STATE OF OHIO
DEPARTMENT OF TRANSPORTATION
HUR-CR 11-2.96
BASELINE ROAD/BROADWAY ST.
VILLAGE OF PLYMOUTH
HURON COUNTY
RICHLAND COUNTY

REPLACEMENT OF A DETERIORATED WOOD BEAM BRIDGE OVER ASHLAND RAILWAY IN VILLAGE OF PLYMOUTH ON EXISTING HORIZONTAL ALIGNMENT AND MODIFIED VERTICAL ALIGNMENT WITH APPROACH ROADWAY WORK.

ADDENDUM 1

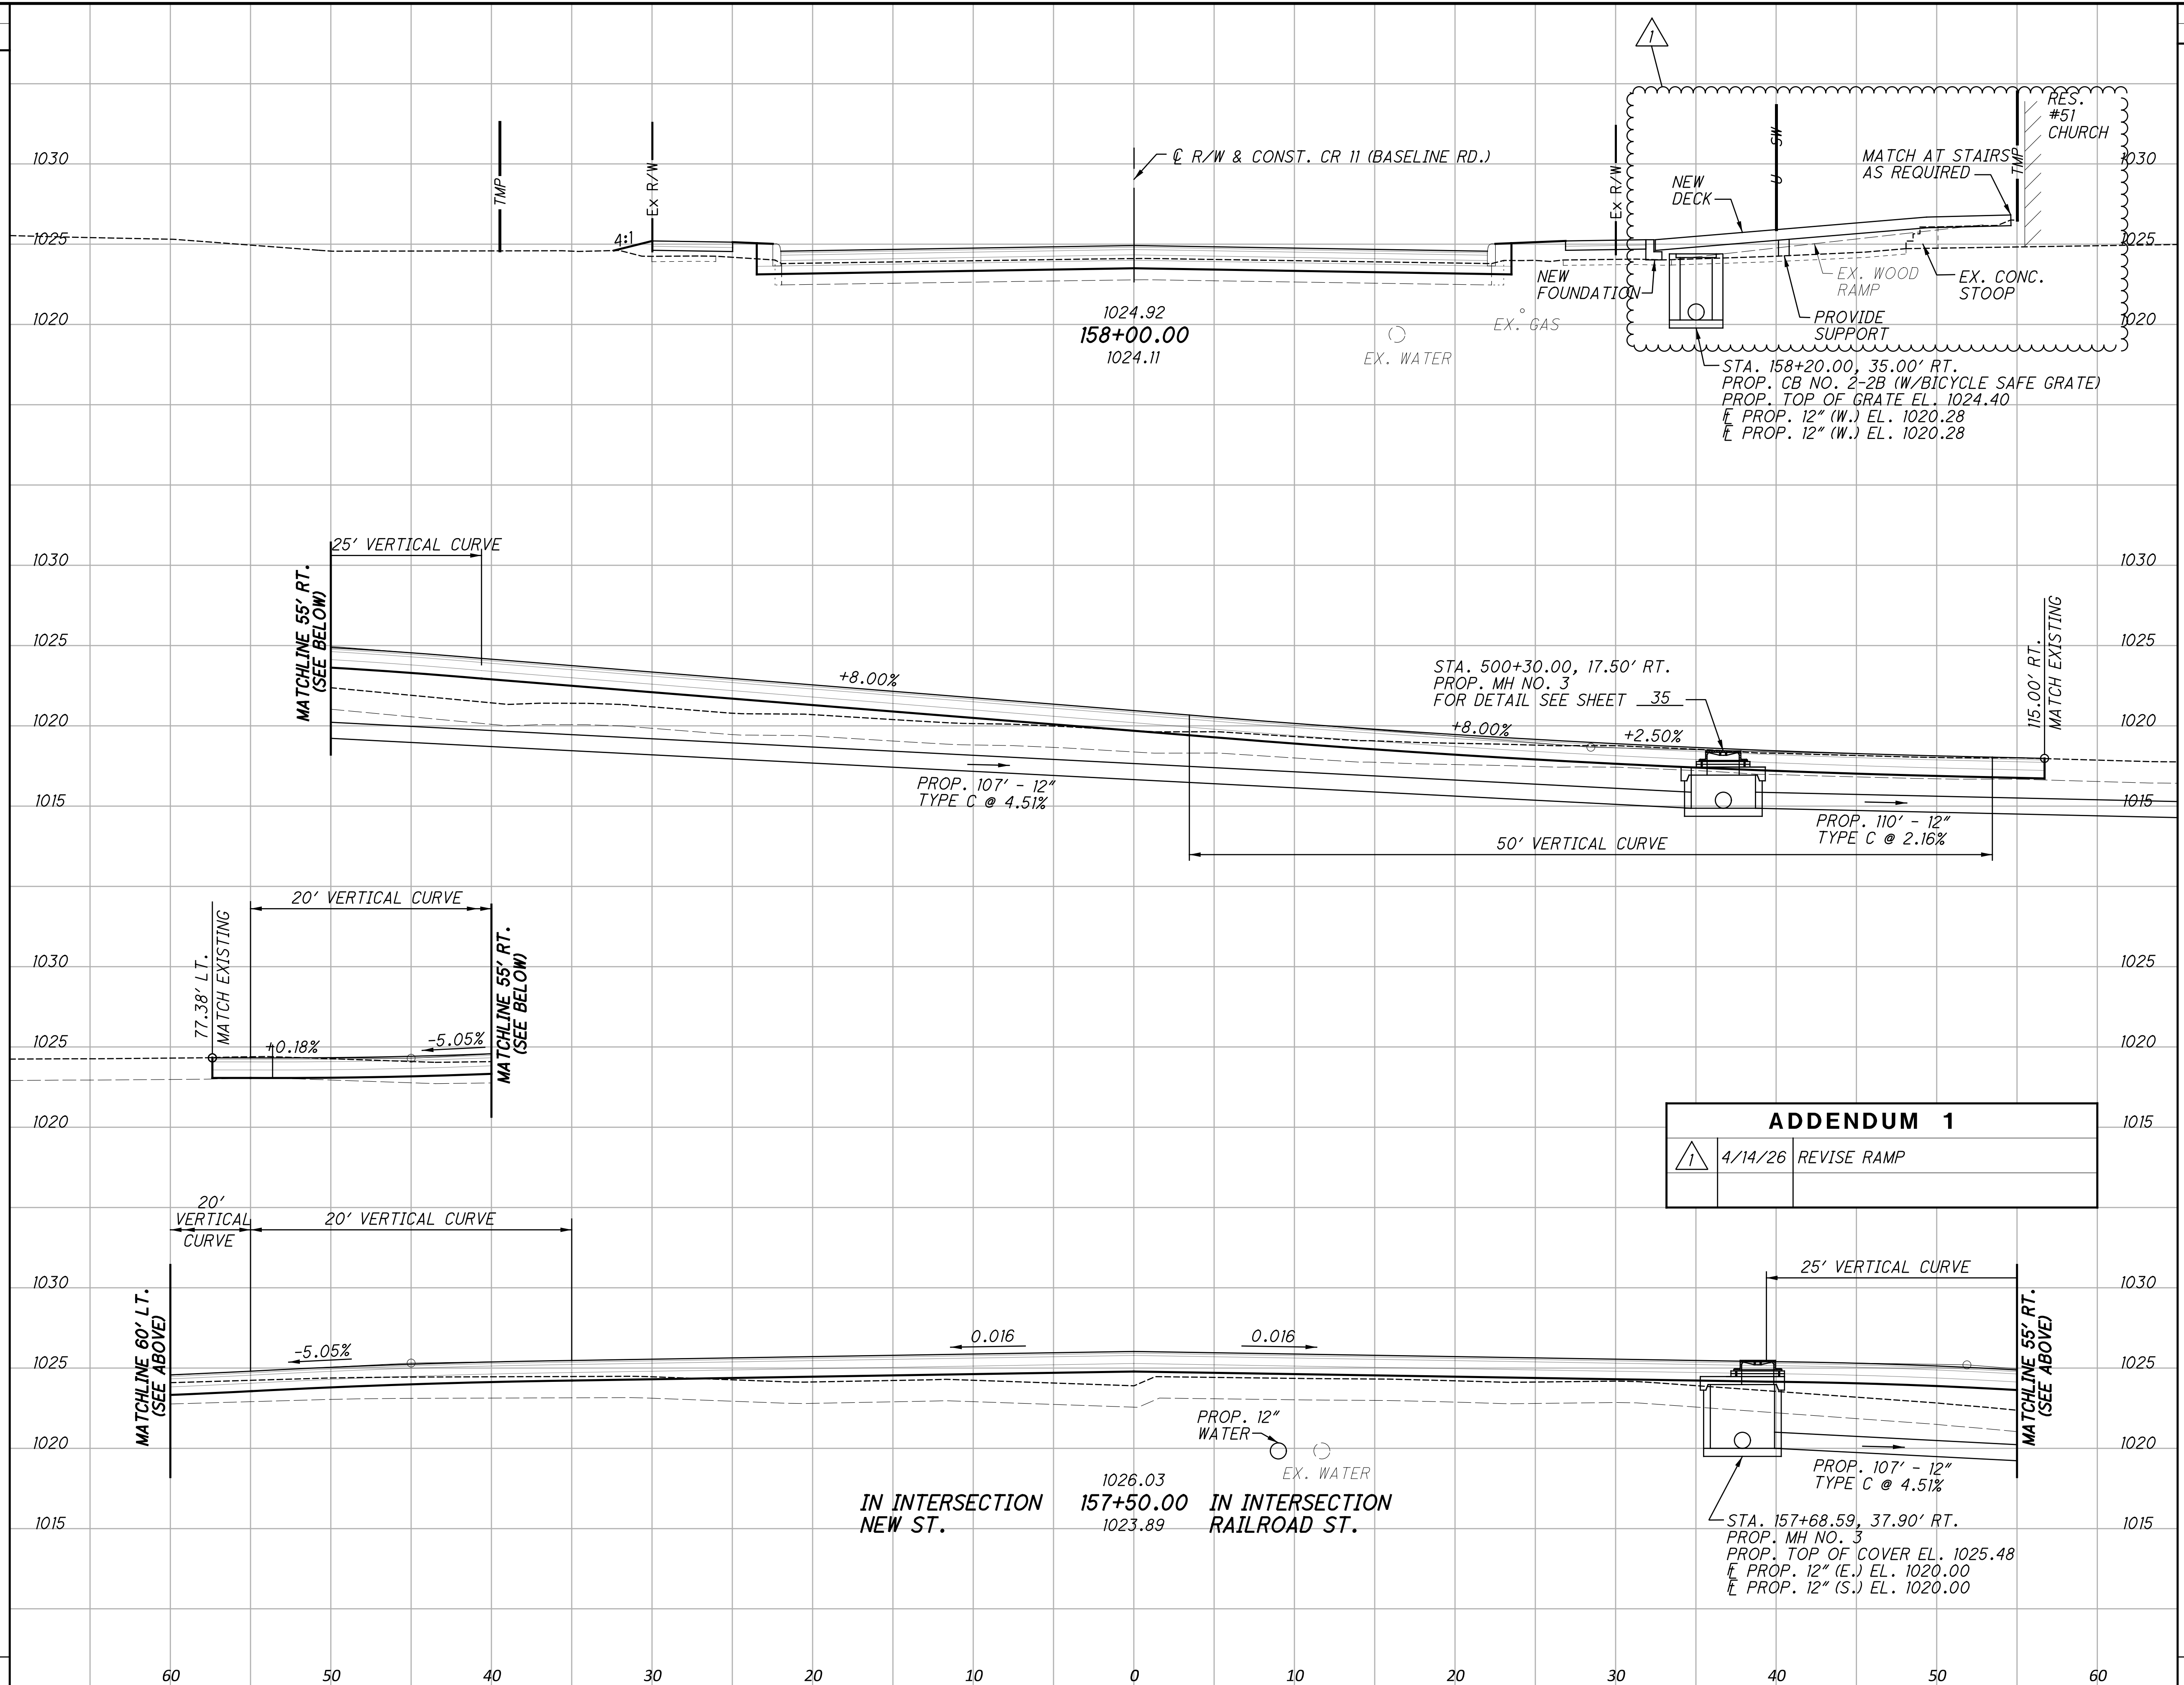
| ADDENDUM 1 | | |
|------------|---------|-------------|
| | 4/14/26 | REVISE RAMP |

PLAN AND PROFILE - RAILROAD ST./NEW ST.
 STA. 500+00.00 TO STA. 61+50.00

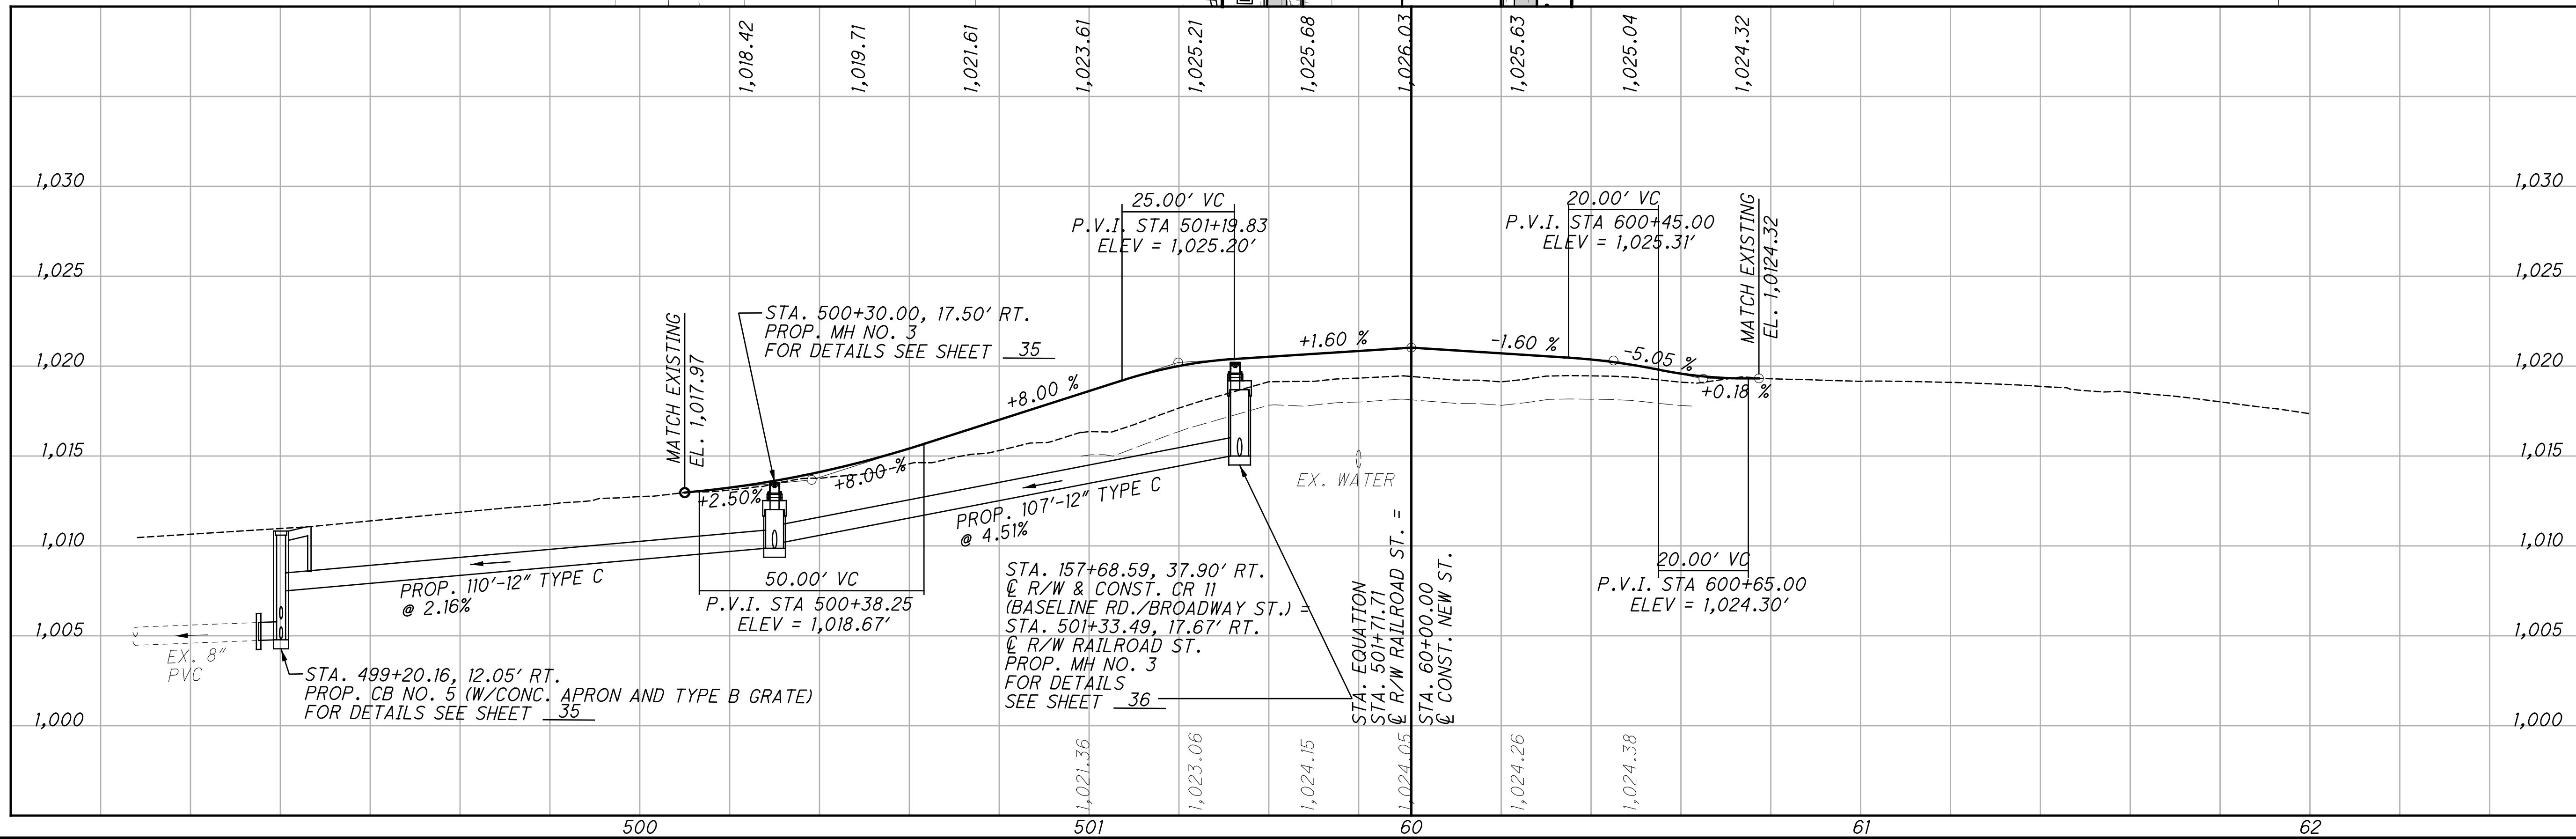
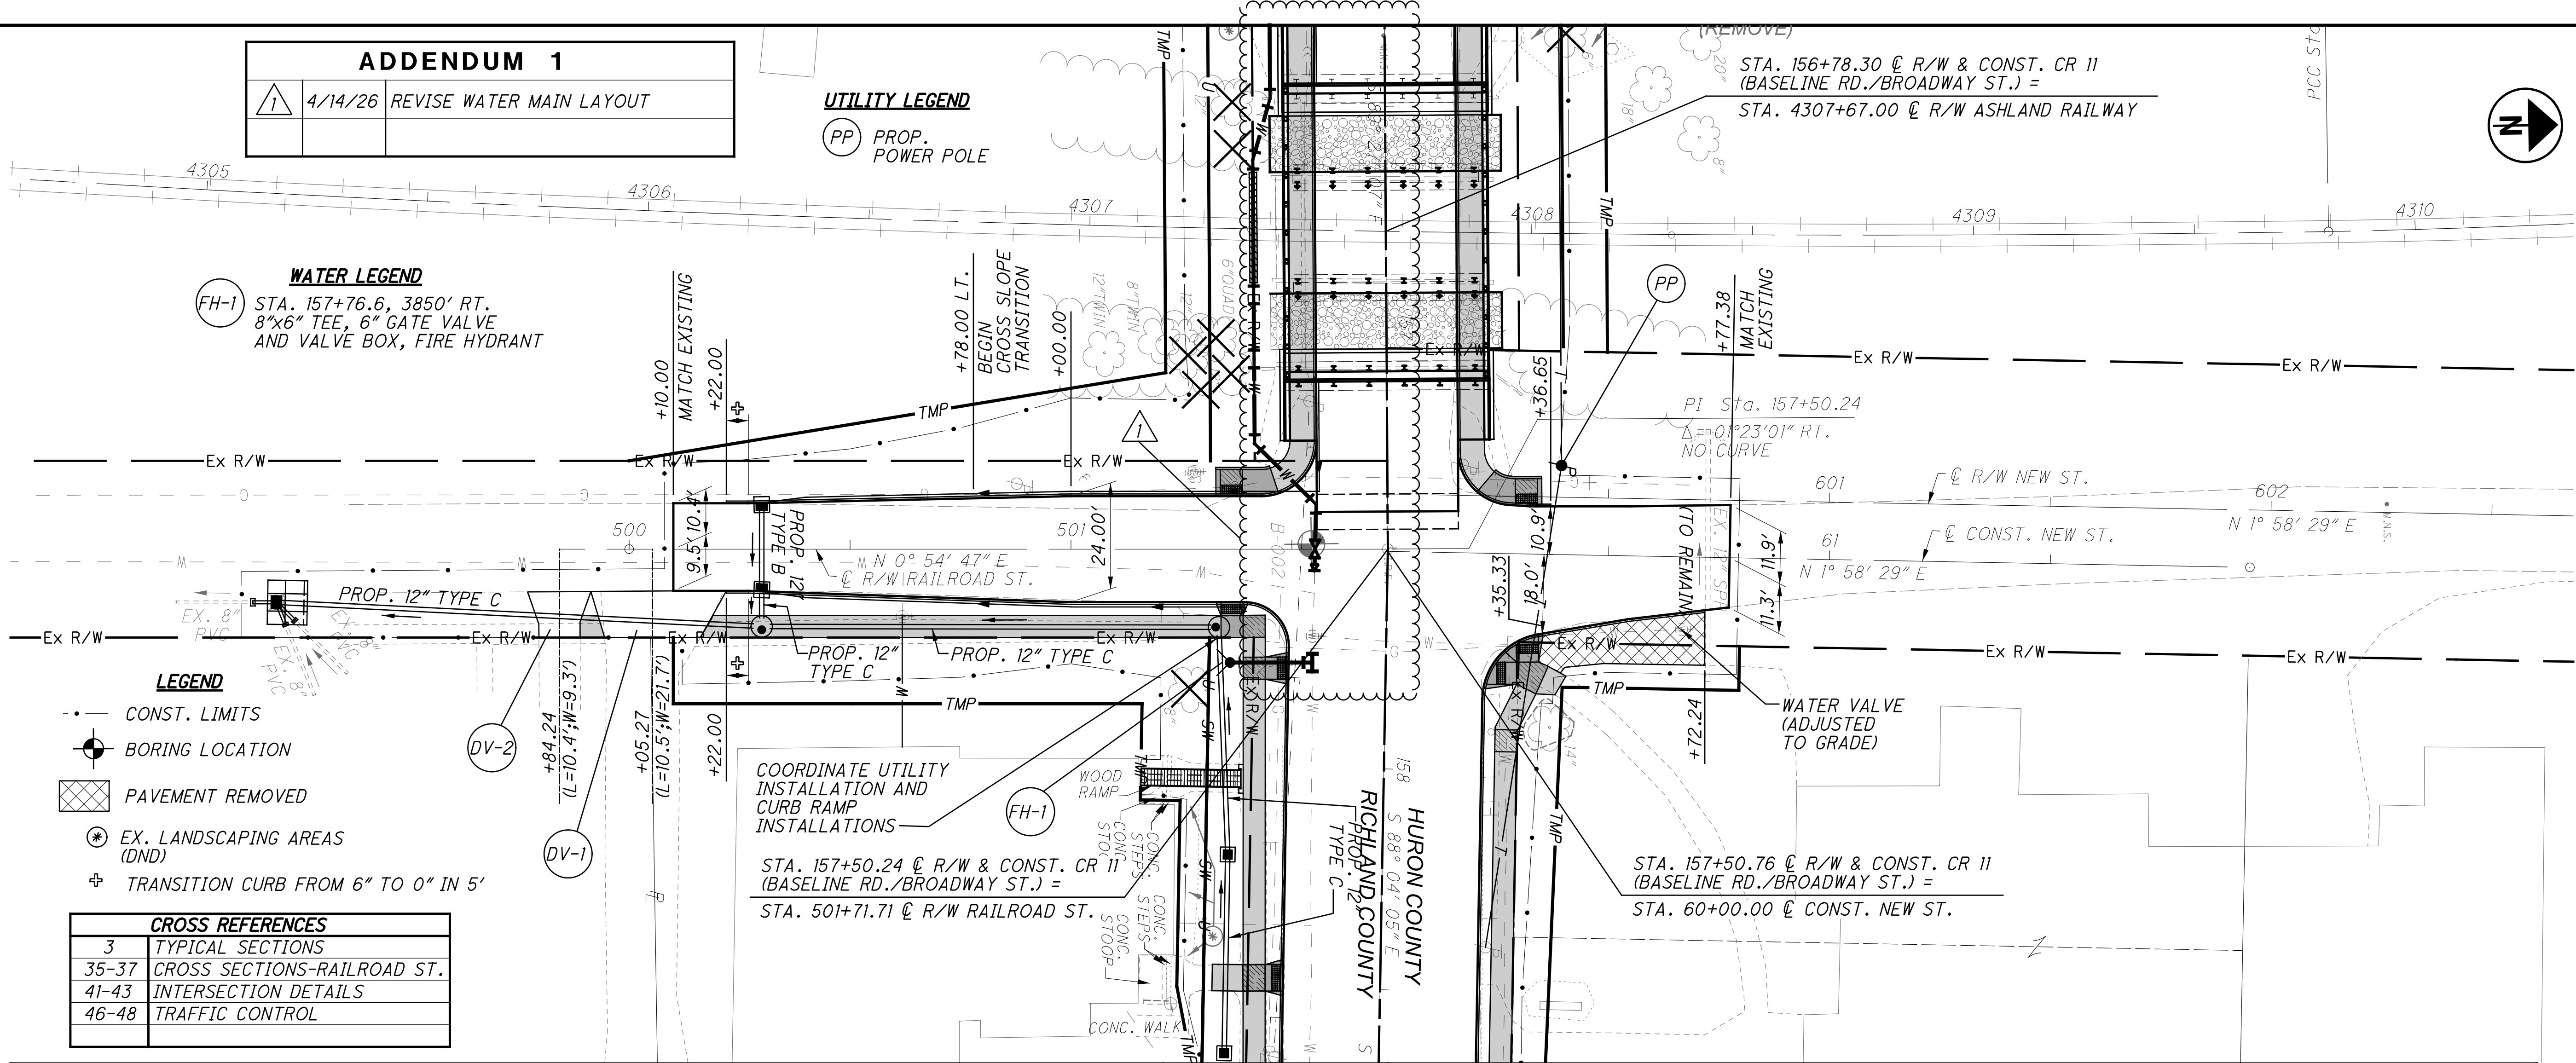
| ADDENDUM 1 | | |
|------------|---------|--------------------------|
| 1 | 4/14/26 | REVISE WATER MAIN LAYOUT |
